Technical Service Bulletin

Topic	Creaking From the Rear of the Vehicle - Diagonal Strut Brace Bolt Loose
Market area	Bentley: worldwide (2WBE),China 796 VW Import Comp. Ltd (Vico), Beijing (6796)
Brand	Bentley
Transaction No.	2076757/1
Level	EH
Status	Released for publishing
Release date	May 12, 2025

25MY Continental GT & Flying Spur

Figure 2

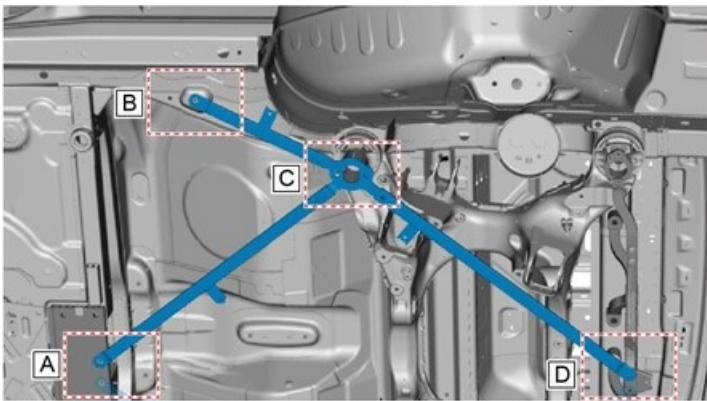
The bolts on either side, highlighted in box B (Figure 2) are coming loose and causing the noises from the diagonal strut brace.

1) Check the torque value of bolt “B”, highlighted in Figure 3, on BOTH sides of the vehicle. Refer to ElsaPro, Repair group 51 “Diagonal Strut Brace – To remove and fit”.

2) If the bolt is not within the specified torque this could be due to contamination. Remove the bolt and replace with the new bolt (see parts information).

Before replacing the bolt ensure the thread is cleaned to remove any wax.

New part number for bolt “B” – N.909.201.02
